City of Conway Planning Commission Staff Report

7:00pm • January 16, 2018 • 810 Parkway Avenue

CONWAY CITY PLANNING DEPARTMENT REVIEW OF CENTERSTONE PHASE V SUBDIVISION PRELIMINARY PLAT

Proposed Preliminary Plat

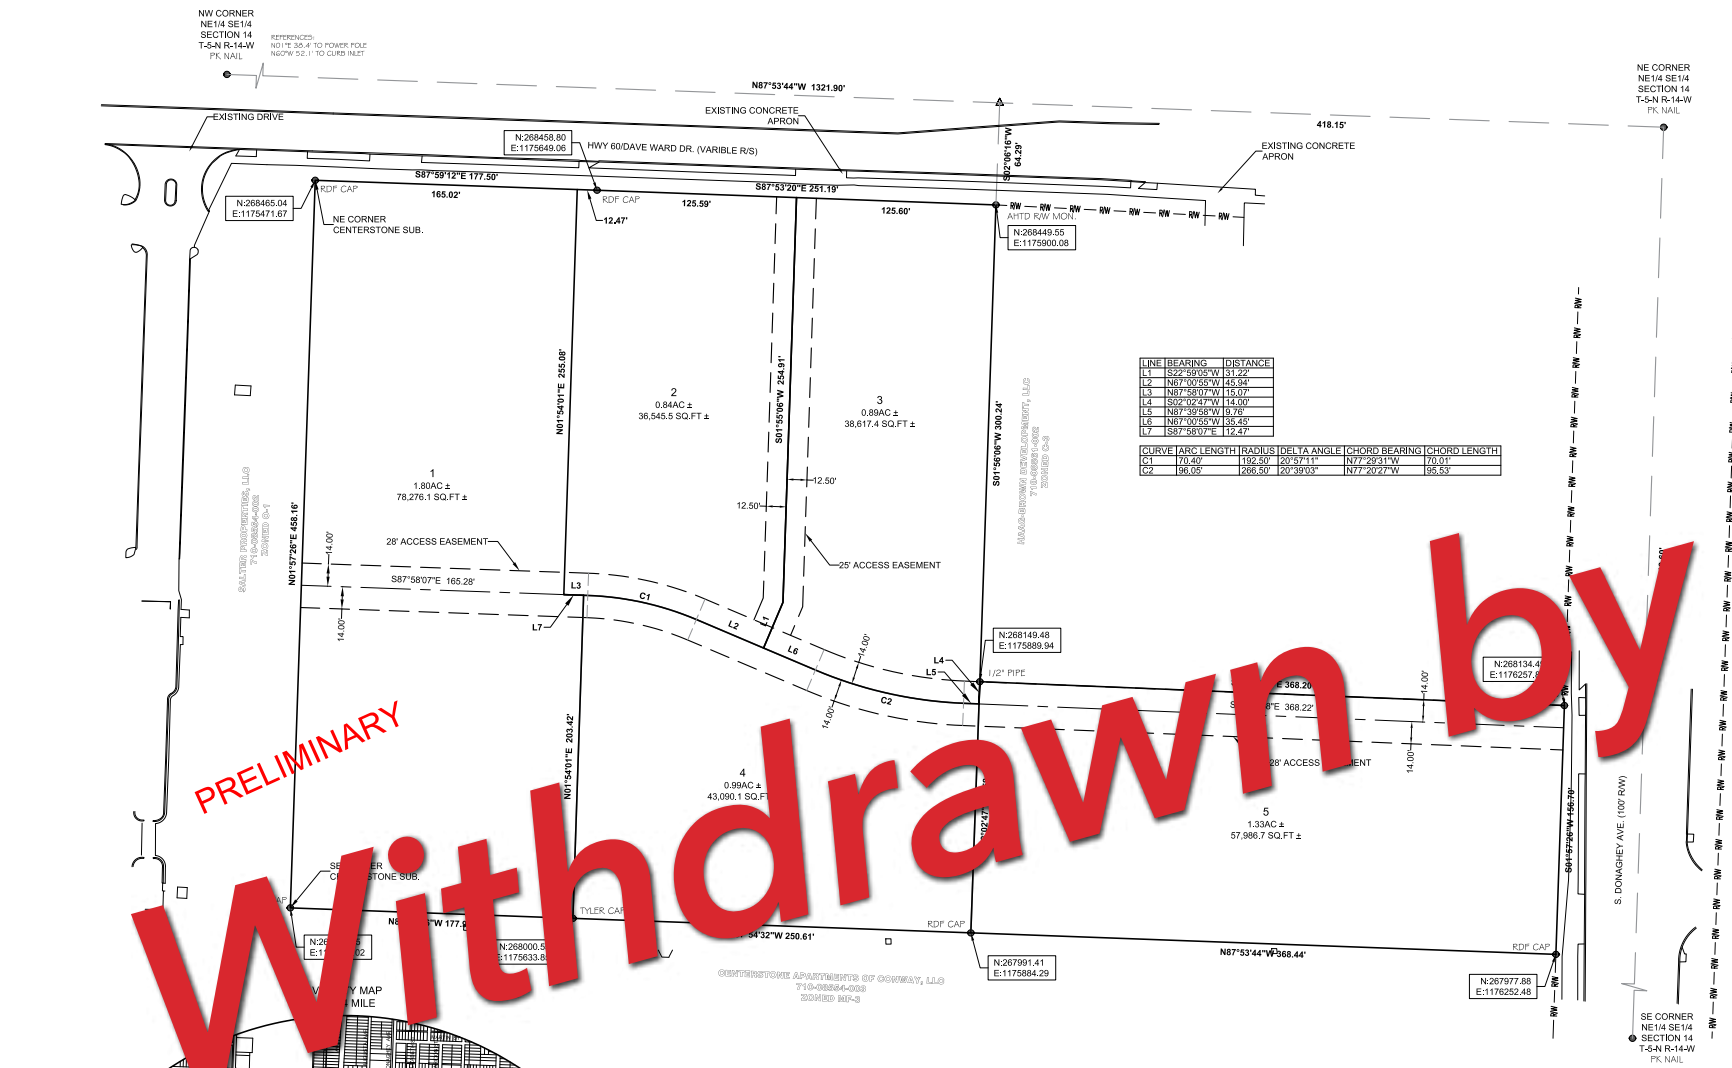
29. Property line corners at street intersections shall be rounded with a radius of at least 28 feet.
30. Street intersections shall be located to avoid creating hazardous driving conditions. **Verification of State Highway approval for the curb cut on Dave Ward drive is Required / Not Required.**

34. Blocks over 1000 feet in length may require a public crosswalk within a dedicated easement of not less than 15 feet in width including a paved crosswalk not less than five feet in width to provide pedestrian circulation. **A pedestrian access easement between lots 1 & 4, and an entry gate from Centerstone Apt's to the south to allow pedestrian circulation from apartments to the 28' Access Easement is Required / Not Required.**

37. Sidewalks As Part of Commercial, Multi-Family, and Mixed Use Developments: Sidewalks along streets in commercial, multi-family, and mixed use subdivisions shall be constructed concurrently with building construction as part of site development review. Sidewalks shall be the responsibility of the builder/owner and not the developer. The sidewalk shall be installed prior to the final inspection and issuance of a certificate of occupancy. However, the developer of commercial subdivisions/ replats with pre-existing development shall be required to meet the sidewalk provisions of Article 1101 Development Review of the Conway Zoning Ordinance. Sidewalks along the 28' Access Easement will be required as part of the development review process for each lot. Replace the Sidewalk not "Classified as Residential" with this to Sidewalk note. In addition, sidewalks and pedestrian easements are needed adjacent to or within both the 28' and 25' Public Access Easements.

Staff recommends the approval of the preliminary plat subject to the amended plat list.

D1 RECONSIDERATION OF CLUB VILLAS PUD AMENDMENT REQUEST

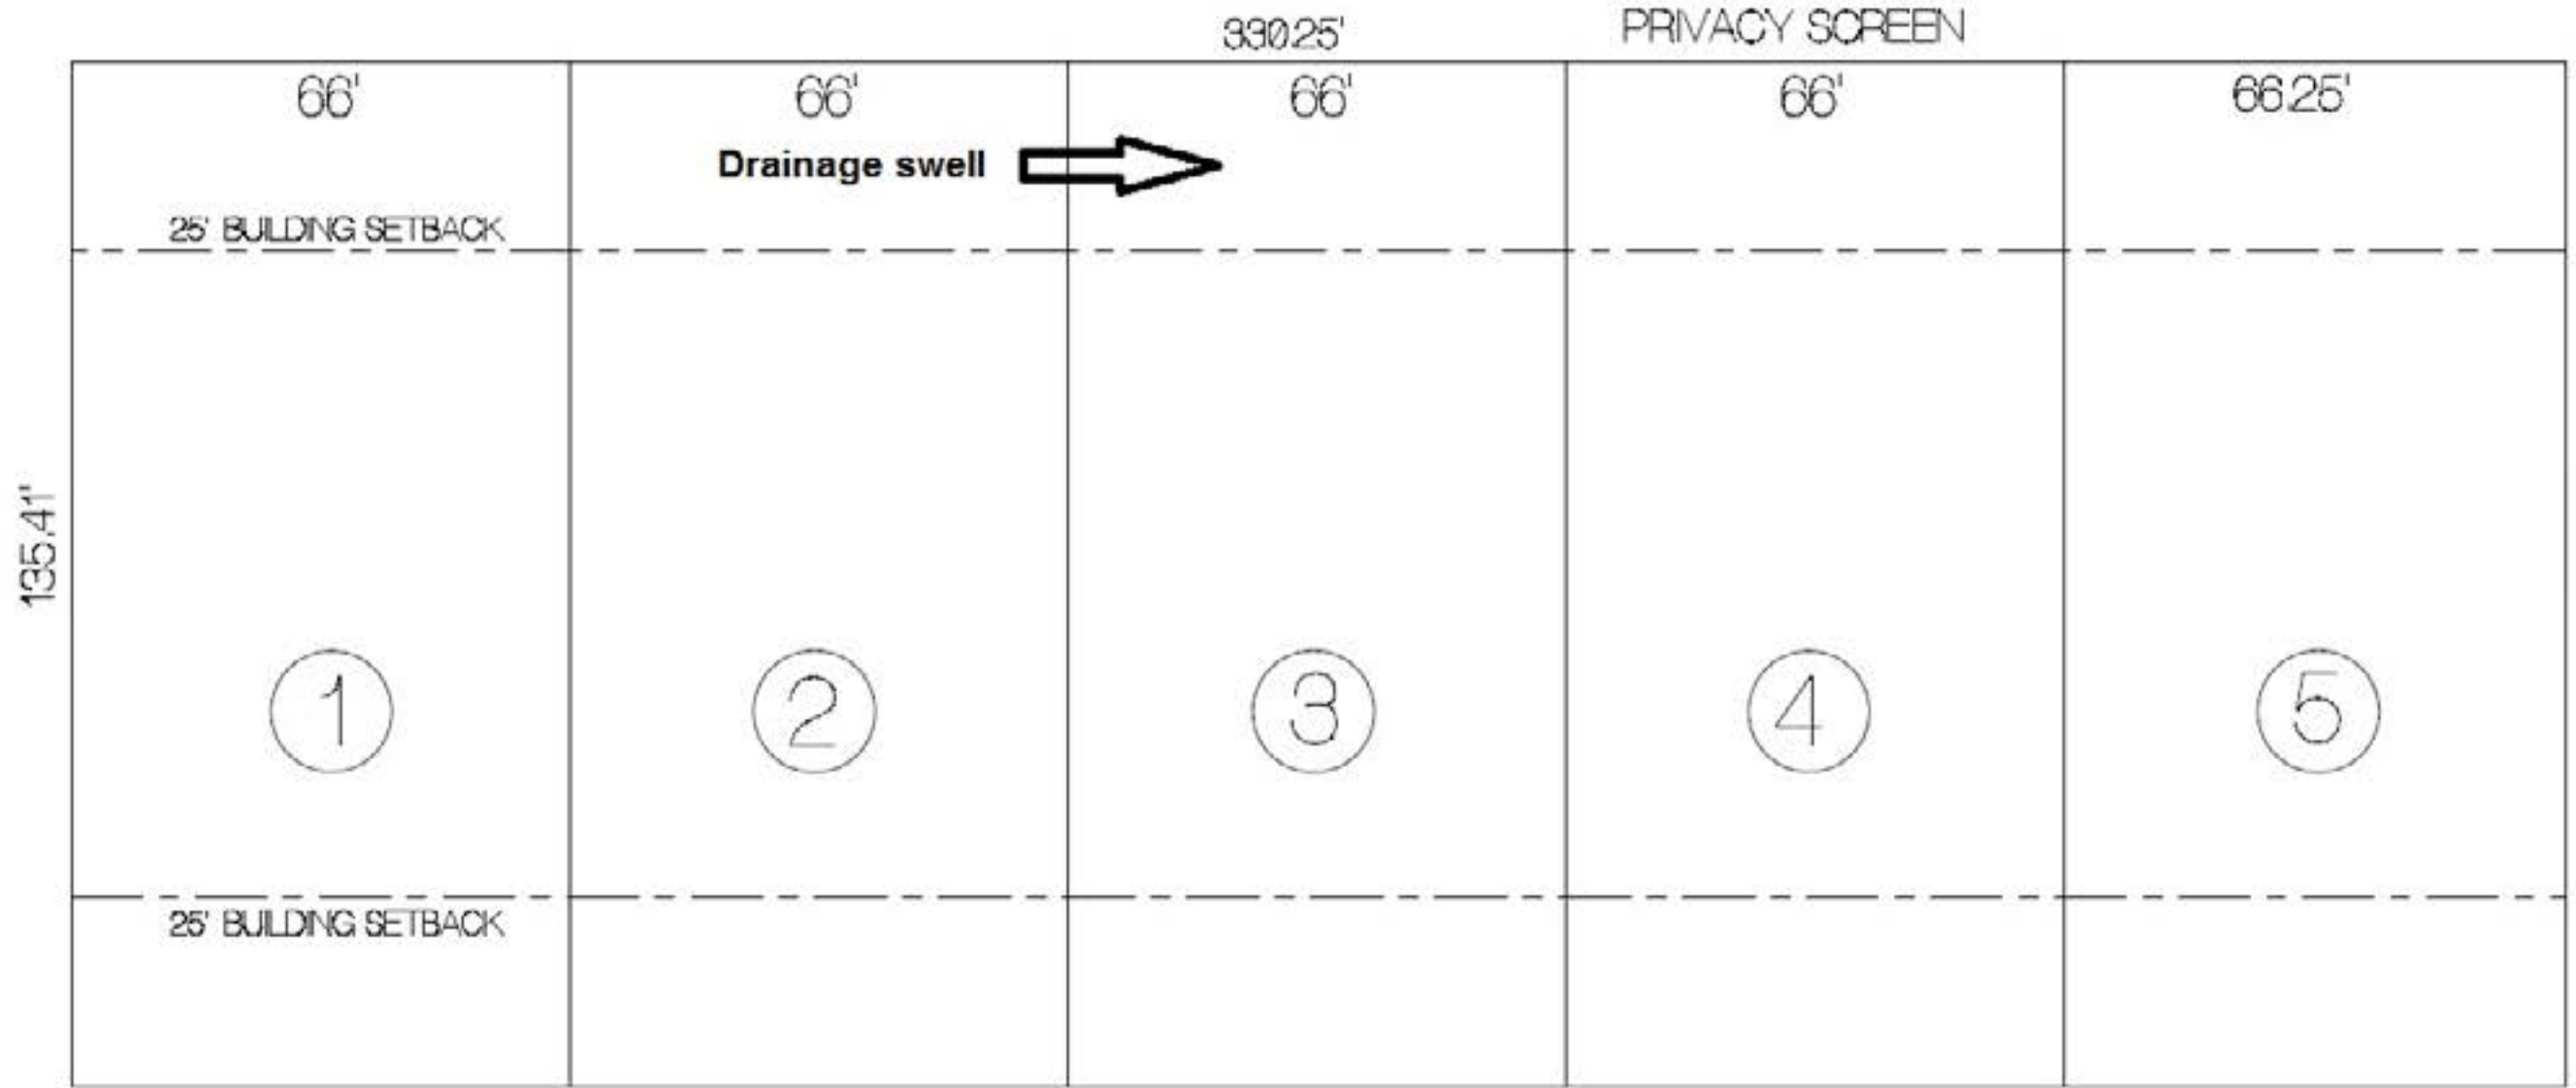
- Revised site plan for reconsideration.
- 5 Lots - each 66' wide with 25' front and rear building setbacks and 6' side building setbacks
 - Screening area on west side of all lots
 - Drainage swell on west side of all lots
 - Second floor windows facing south and east only
 - No shared driveways
 - Previous concept of craftsman style homes abandoned under new plan

Proposed Site Plan

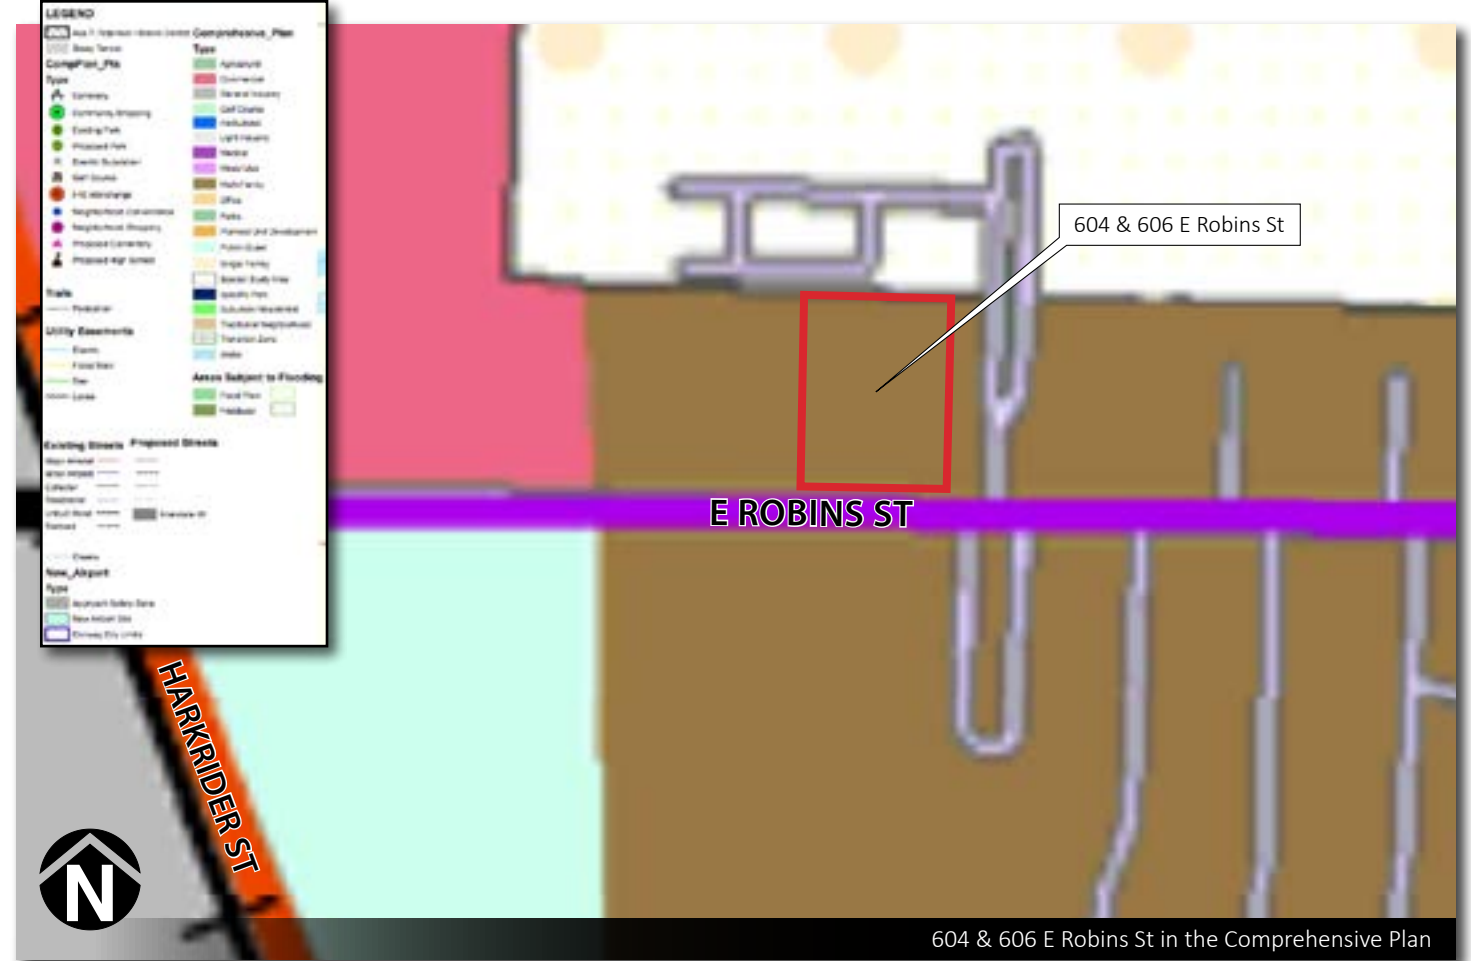
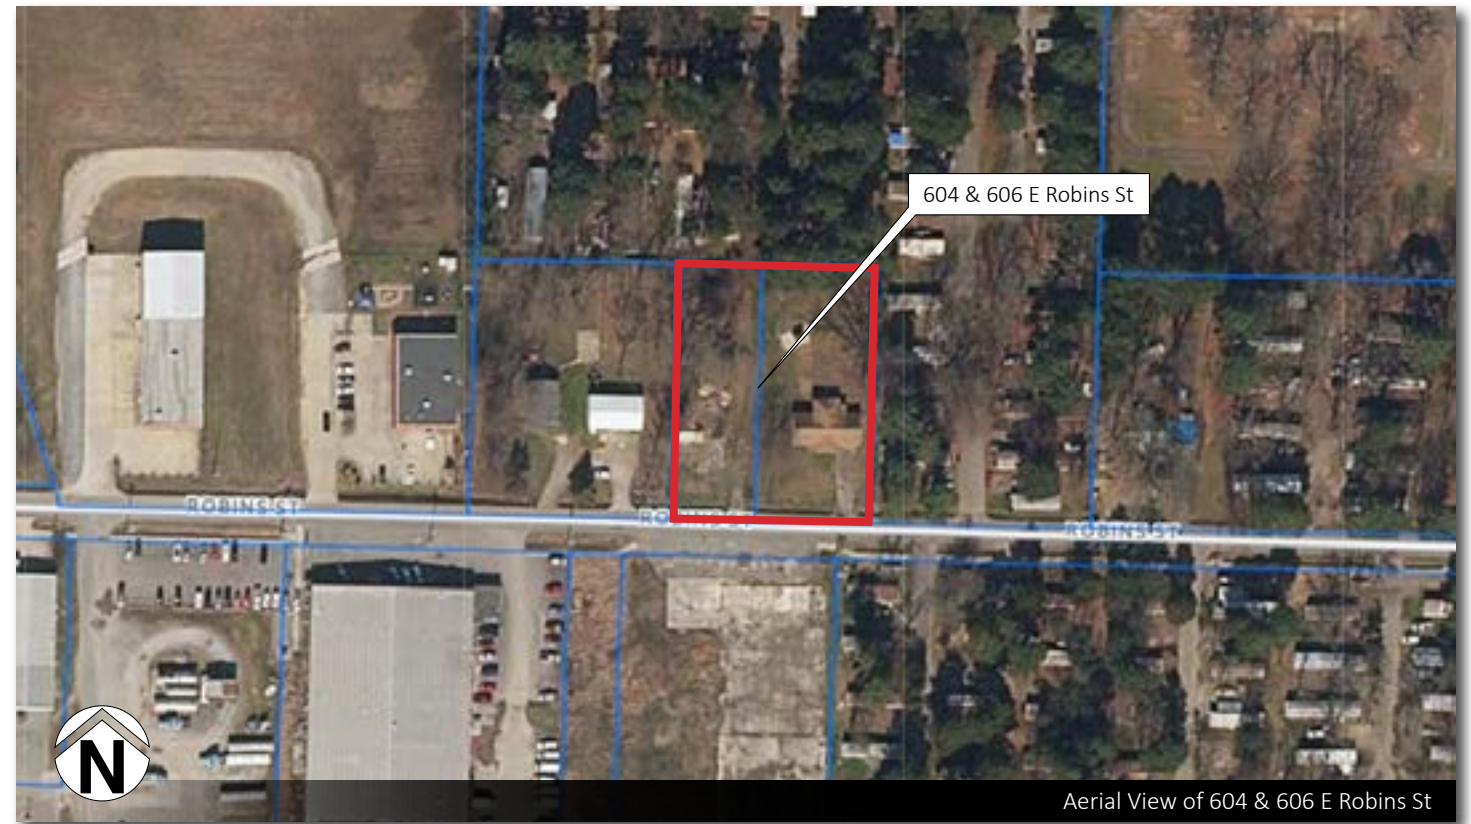
- **Relation to Utilities and Major Roads.** A PUD shall be located in relation to utility systems, drainage systems, and major roads so that neither extension or enlargement of public facilities shall be at the public's expense. *The proposal would not create any additional expense to the public. Additional right of way dedication will be required along East Robins. The existing property line appears to be in the street; possibly the centerline. Robins Street is shown as a minor arterial on the Conway Master Street Plan requiring an 80 foot total right of way width. Additional right of way dedication could potentially take up to 40 feet of the proposed development's street frontage. This required right of way dedication will affect the placement of the cottages closest to E Robins Street.*

- **Internal Street Network.** A PUD shall include an internal system of streets, parking aisles, and/or cross access drives that can safely and efficiently accommodate vehicular traffic generated by the PUD. *The proposed cottages would be accessed from a driveway that leads to individual parking spaces and a community parking area. 5 individual parking spaces are provided for the 1 bedroom units. 6 parking spaces are shown in the parking area in front of the clubhouse.*

- **Sidewalk System.** Unless there are outstanding reasons that warrant otherwise, all internal streets within the PUD shall include pedestrian sidewalks. *The submitted site plan shows sidewalks connecting the cottages to the parking area, clubhouse, and existing house. A sidewalk could possibly be constructed along the East Robins street frontage. However, Robins is an open ditch road and will likely be upgraded at some point in the future as the Old Airport redevelops. A new sidewalk was constructed along the south side of East Robins a few years ago. Due to these circumstances, a sidewalk in-lieu fee might be appropriate.*

- **Common Space.** The incorporation of plazas, courtyards, and other outdoor spaces for people to gather is encouraged. *The side and front yard area of the existing house will remain. This open area could become once building locations are reconfigured due to right of way dedication.*

- **Green Space.** PUDs over 3 acres in area shall dedicate a minimum of 20% of the development as green space. Green space is defined as pervious surface typically reserved for green space and/or landscaping. *This project is less than 3 acres and 20% green space is not required. However, there appears to be well over 20%. This percentage will likely decrease once the site plan is reconfigured.*

- **Required Meetings.** A PUD request requires two specific meetings prior to the Planning Commission public hearing; a development review meeting and a public informational meeting. The development review meeting was held on October 30, 2017 at City Hall. *This meeting is a technical meeting between the applicant and city officials to determine any technical development issues. Discussion centered on utility easements, fire access, drainage, and additional right of way. Right of way and fire equipment access will need to be further reviewed.*

1. PUD shall be generally developed as shown on the submitted site plan and building perspectives. Minor modifications of the submitted plan shall be allowed for technical reasons. However, the density and intent of the site plan shall be followed. The plans may be revised to reflect right of way dedication, easements, fire access, etc. The Director of Planning may approve necessary modifications.

2. A lot merger shall be required. Any additional rights of way, sidewalks, etc. as required by the Subdivision Ordinance shall be dedicated and constructed. Right of way per the Master Street Plan along East Robins Street shall be dedicated as part of the merger process.

3. Setbacks, utility/pedestrian easements, public rights of way, etc shall be defined in the final development plan, plat, and PUD documents.
4. An sidewalk in-lieu fee may be paid instead of constructing a sidewalk along East Robins Street.
